Subject: **Biomass Boilers at Waste Drying Plant, Gibson Lane, Melton, Hull, HU14 3HH,
 Air Quality Assessment and Odour Assessment
 - Response to the EA’s Comments Issued in the Email Dated 19th November 2021**

Objectives of This Memorandum

Annex A Notice of request for more information – Schedule 5 Issued on 08/12/2021

Figure 1 Plant Layout with Divided Areas

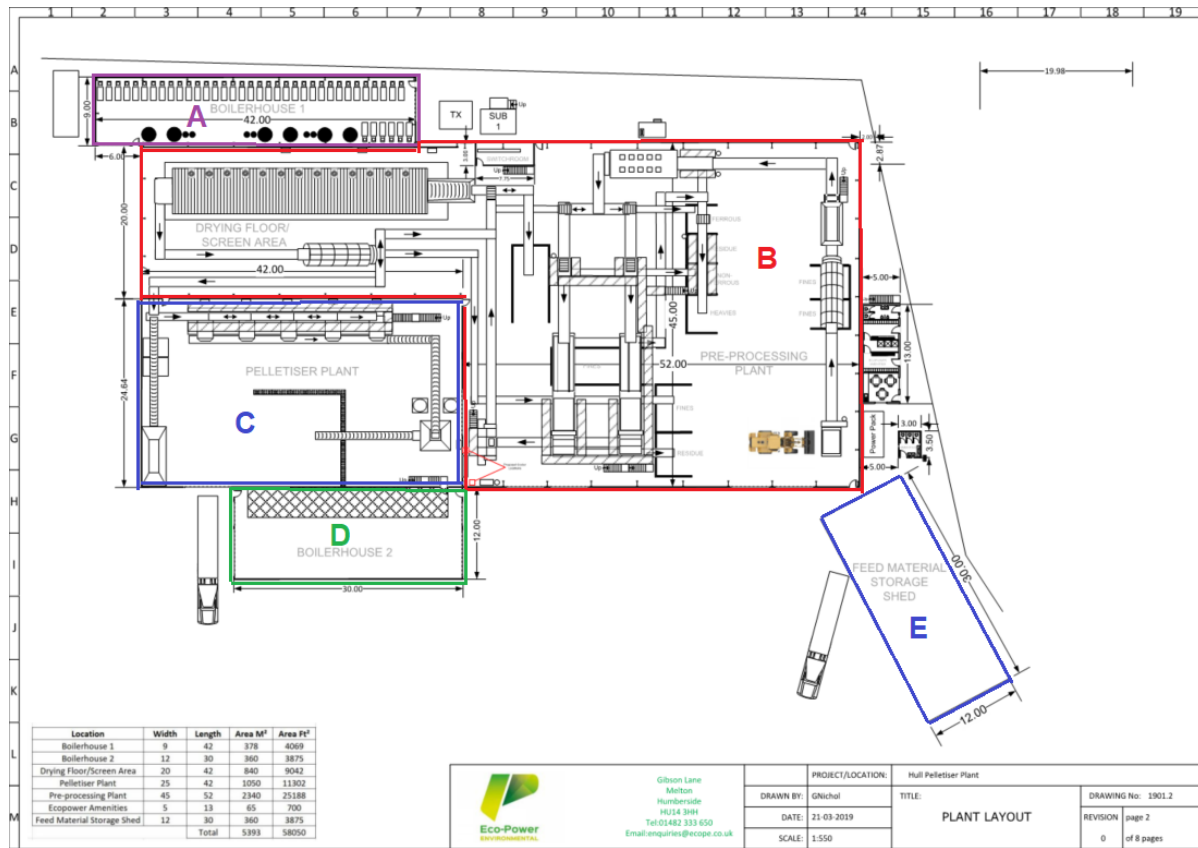
1. *How were the proposed air extraction rates derived and how does this relate to the capacity of the building, answers should respond as a minimum to the points given here.*

Reason: We would expect to see a clear rationale behind the air extraction rate and building capacity i.e. what is the building volume and how does this relate to air changes per hour under different extraction scenarios namely:

- *The dust extraction system is connected to the areas of the treatment shed where we would expect to see maximum odour potential. Other than dust being removed from the extracted air there is no proposal to treat to reduce odour therefore the dust extraction system is a potential odour source. This would be exacerbated during dry periods when waste will need less drying and therefore the dust extraction system would be the primary means of maintaining negative pressure.*
- *It is not clear when the dust extraction system will be in use i.e. if it is only during active waste treatment then when waste is stored but not being treated the extraction system may not be in use and the building will not be under negative pressure (such as during the night).*

Air extraction rate:

The plant is divided into 5 separated areas as shown in Figure 1 below.

- Area A: Boiler House 1
- Area B: Drying Floor Area and Pre-Processing Area;
- Area C: Pelletiser Plant;
- Area D: Boiler House 2 – It becomes a storage area; and
- Area E: Storage Shed areas.

Area A and Area B are separated by a wall. Area B and Area C are also separated by walls.

The air exchange rate for the Area A boiler house has not been calculated and presented as it is only housing the boilers and wood logs. The wood logs materials have low potential for dust or odour emissions.

The air exchange rate for Area B and Area C has been calculated as below.

The estimated air exchange rate: 136,118 / 25,914 = 5.25 air exchange rate per hour

Therefore, when the drying floor and the dust extraction system are in operation, the estimated air exchange rate is approximately 5 air exchange rate per hour

The estimated air exchange rate: 40,000 / 6799 = 5.88 air exchange rate per hour

Therefore, when the cooling of the SRF pellets is in operation, the estimated air exchange rate is approximately 6 air exchange rate per hour.
